# Response to Consultation Documents:

## *Comments on Integrated Resource Plan Proposal Consultation*

### **Response to Consultation Document 2018 10 02**

**Regulatory Authority of Bermuda**  
**Response to Consultation Document 2018 05 02**  
**(Integrated Resource Plan Proposal Consultation)**

Figure 1 - Bermuda National Energy Policy - Targets

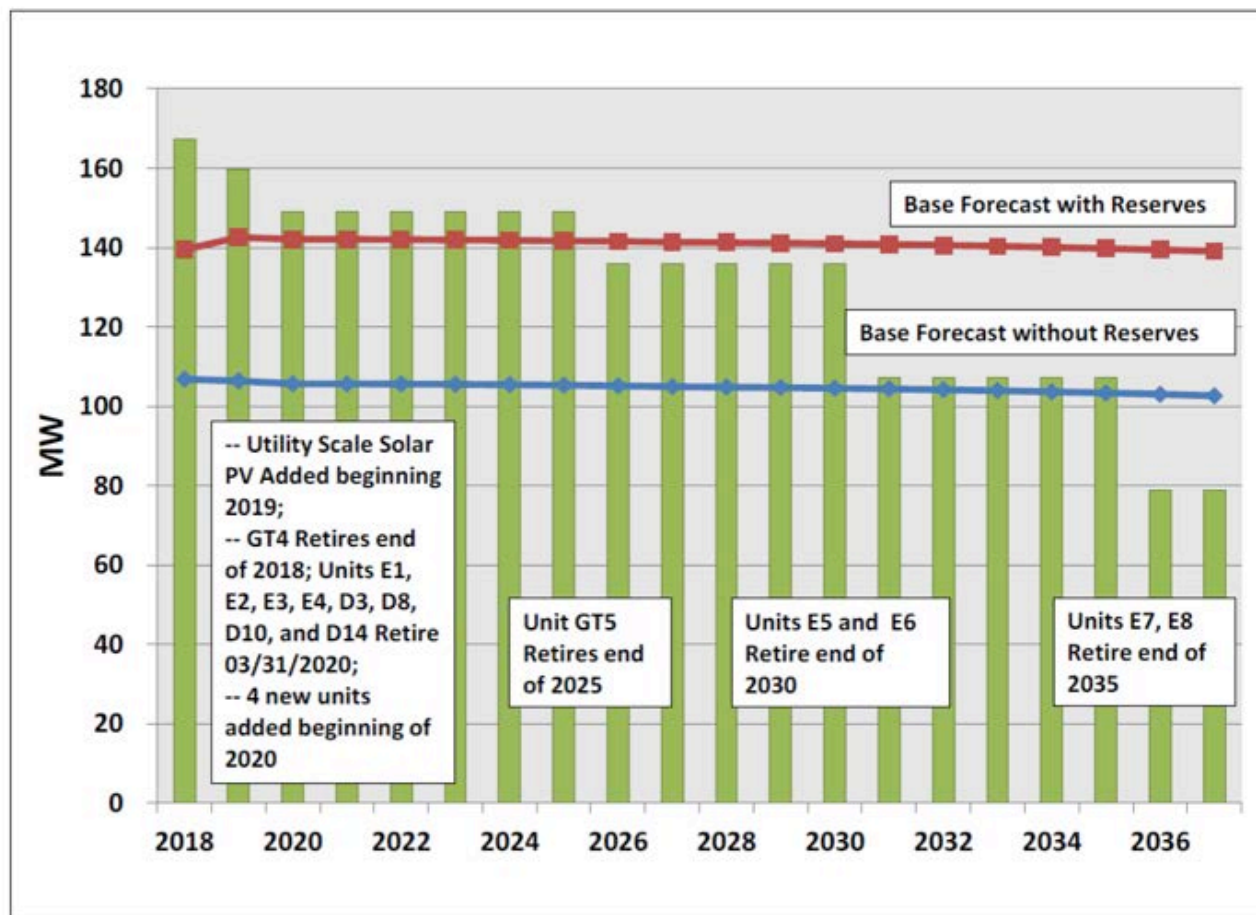
2. The provisions fail to hold BELCO accountable for the information provided or demonstrate how they align with the targets set out in the Government's National Energy Policy. Figure 13 (from the National Energy Policy) below shows the Government's indicative targets - BELCO's plan should indicate how it measures up to the national targets.

The National IRP should more appropriately reflect the goals and objectives of the National Energy Policy and Targets (Figure 1). Clearly, the TD&R Licensee has no interest in funding initiatives that will promote Distributed Generation or IPPs, Demand-Side-Management, Energy Efficiency, or any initiatives that will reduce their kilowatt hour sales and revenue. Hence, their submission "considers" these technologies but offers no solutions or programs to pursue any of them.

Figure 12 - BELCO Integrated Resource Planning Proposal – Scenario 2

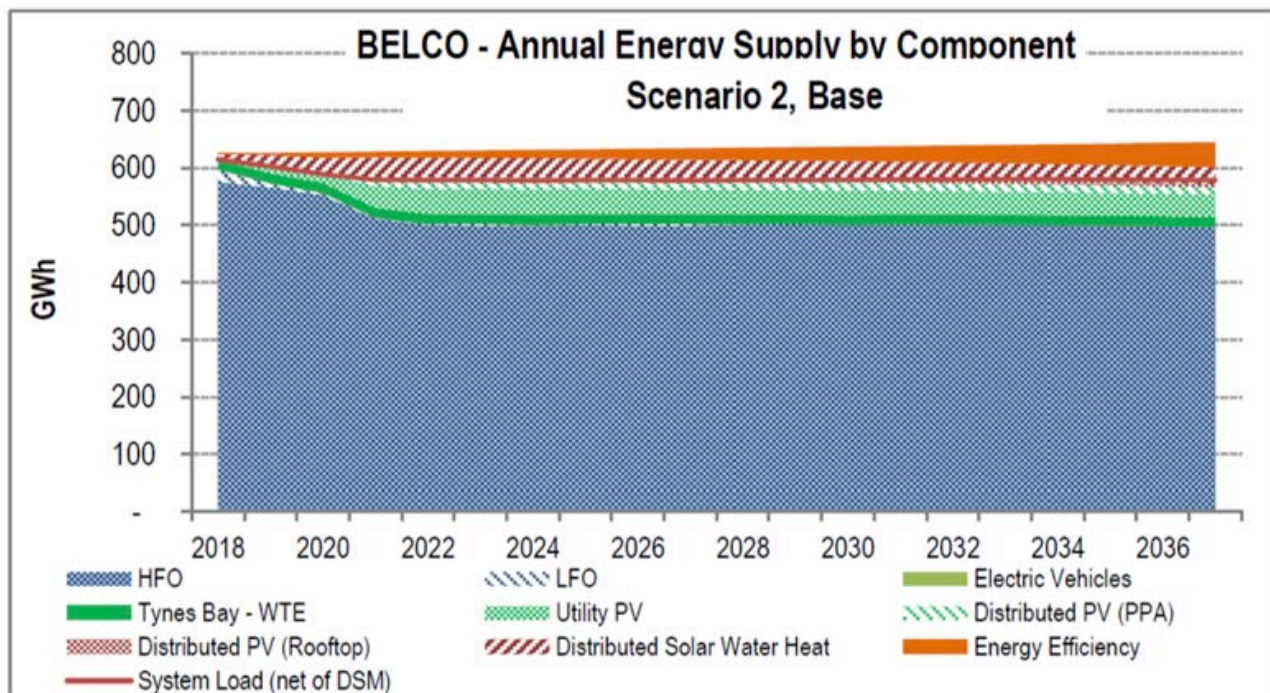
plant. So, despite their public declarations about LNG over the past few years they will not actually be bringing LNG to the island. Hence; their actual contribution to the future energy mix in Bermuda is better reflected by Figure 12 below.

Scenario 2 in Figure 12 is clearly a “business as usual” scenario. On the other hand, a floating energy solution would provide the infrastructure required to transform the island to an LNG environment and produce a energy mix more closely aligned with the Bermuda National Energy Policy displayed in Figure 13.

Figure 13 - Bermuda National Energy Policy – Aspirational Electricity Matrix

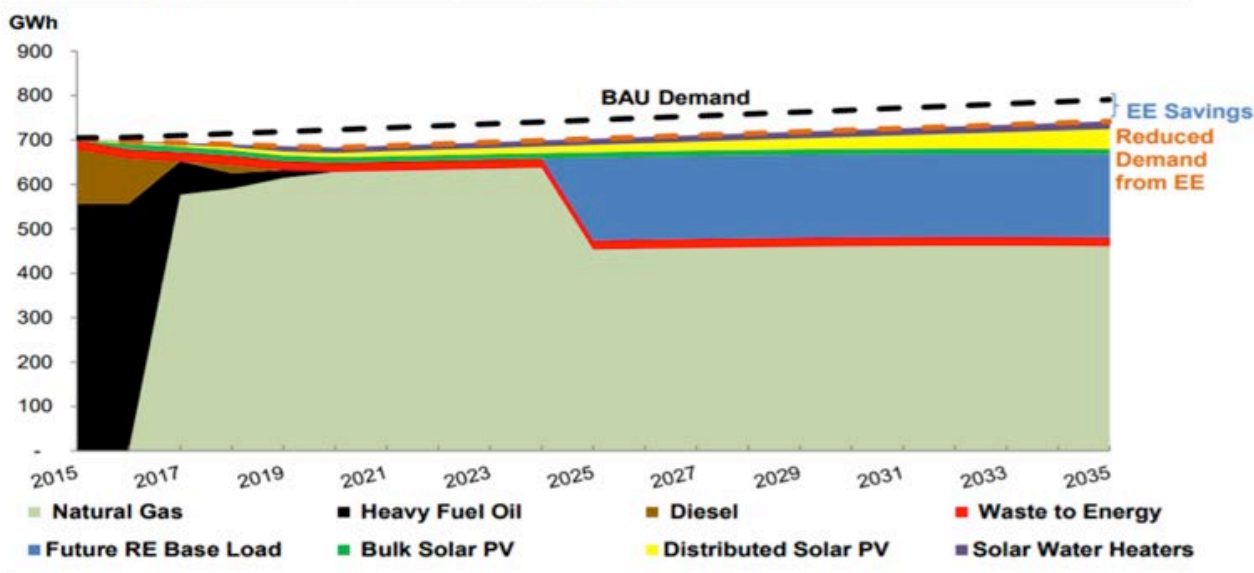
A floating energy solution could provide the 56MW capacity on PPA terms over a period of 10, 15, or 20 years. This gives us the security of having a reliable supply for as long as we want but allows the penetration of other technologies without the risk of “stranded assets”. In other words, we would not need to invest in the capital infrastructure required to bring LNG to the island which means we won’t be stuck with the asset for 20-30 years if new cleaner or renewable alternatives come to fruition. This would truly enable LNG to be a transition fuel for Bermuda as illustrated in Figure 13.

Floating energy solutions have been deployed across the globe for decades, including places such as; Bangladesh, Papua New Guinea, Dominican Republic, and Jamaica. Given the goals and objects of the National Energy Policy, Figure 13 shows why this solution makes sense for Bermuda. The Floating Energy Solutions checks several boxes for Bermuda and offers these additional benefits:

Figure 1 – Levelised energy cost calculations for Bermuda

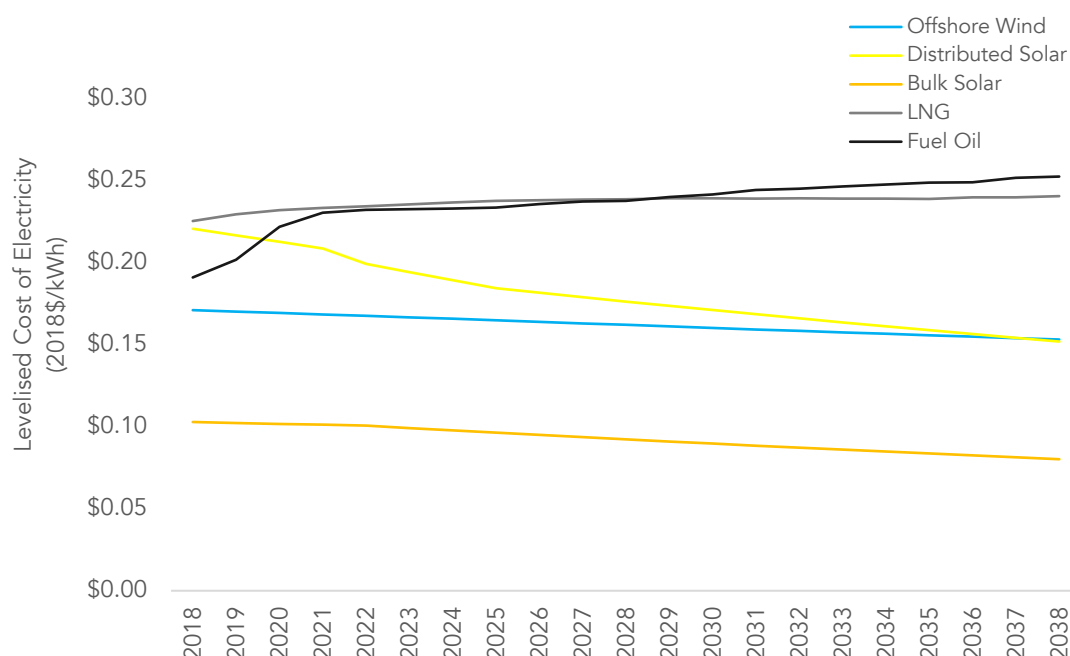
These calculations are both robust and conservative. They indicate clearly that solar photovoltaic and offshore wind technologies are the least-cost sources of electricity available to Bermuda. The accuracy of these calculations is confirmed by the airport solar project, which is contracted to sell power for 10.3¢/kWh, a price that is almost identical to our calculations for 2018.

Fuel oil and LNG represent the most expensive sources of electricity, based on conservative US Energy Information Administration projections for fuel prices over the IRP study period. Our opinion is that actual future costs are likely to be higher. The cost of electricity generated from LNG could be lower relative to fuel oil, however this would depend on the approach to shipping, regasification and storage of the LNG, in addition to future fuel cost trends. Historically, the costs of both fuel oil and LNG have been very volatile.

Figure 2 – Carbon dioxide emissions of electricity in BELCO's IRP and the BBEP compared to the United Kingdom

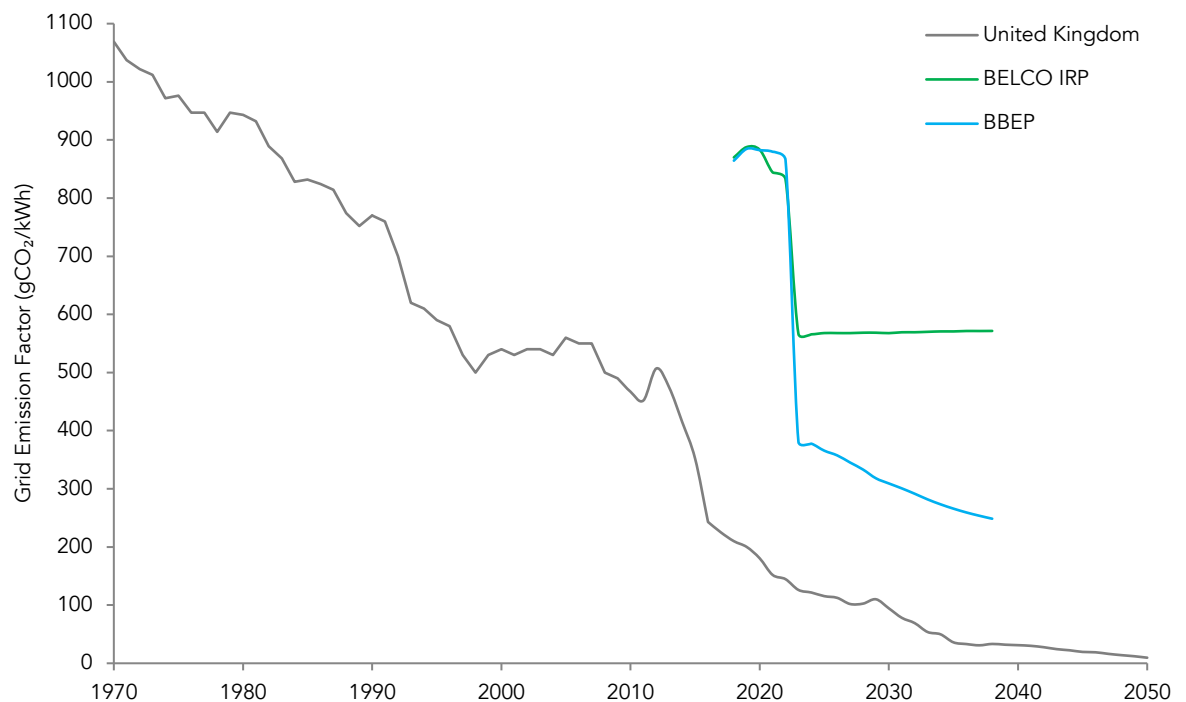
BELCO's original IRP used qualitative analyses of the environmental impact of different generation technologies. We felt it was important to use quantitative analyses to provide a clearer measure of environmental performance. Figure 2 shows the results of our analysis, and provides international context. It shows the emissions that would arise under BELCO's IRP and the BBEP IRP using the United Kingdom for comparison as an example of a country that has committed to decarbonising its electricity supply.

Figure 3 – Areas impacted by sea level rise (©BNT 2010)

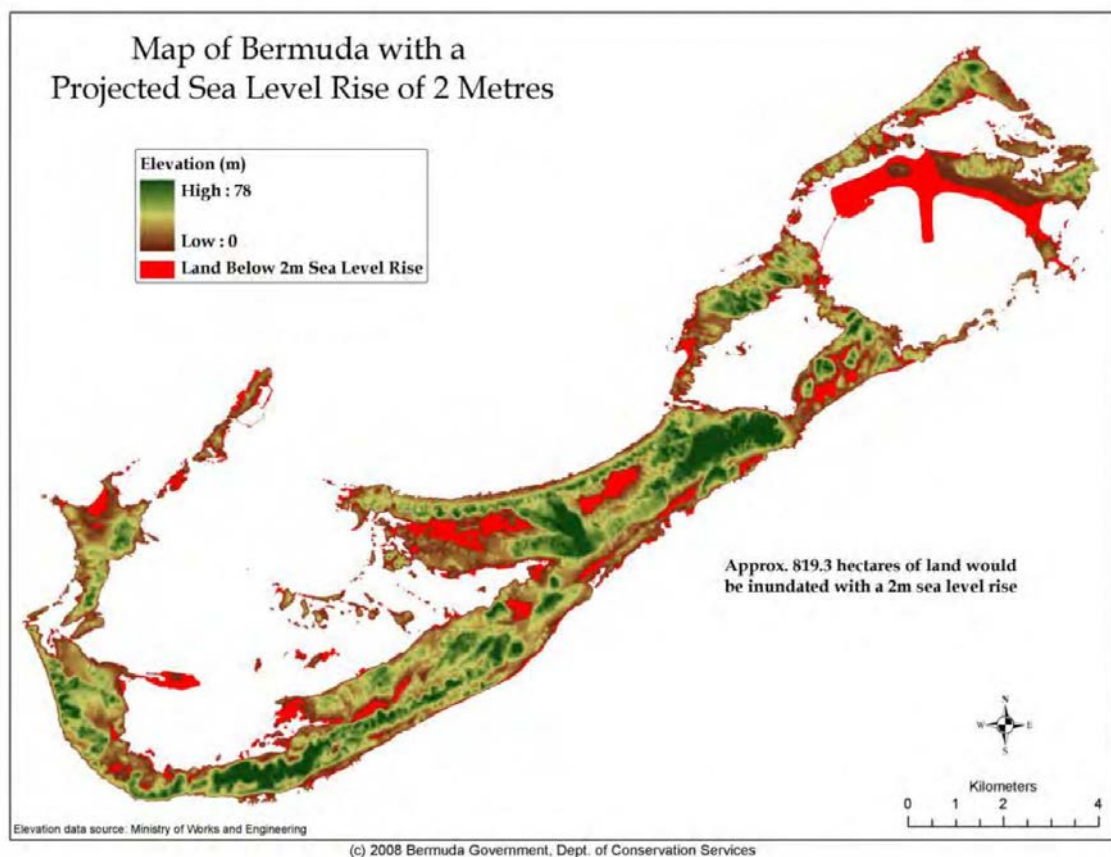
The elevation of the site is also a concern, with the Bermuda National Trust's report<sup>4</sup> on the effect of sea level rise in Bermuda forecasting this area will be one of the first to be inundated. While a two-metre increase in sea levels represents the higher end of forecasts over the next eighty years, the relative level of risk for this site from more modest sea level rise in combination with storm surge appears to be a more valid concern.
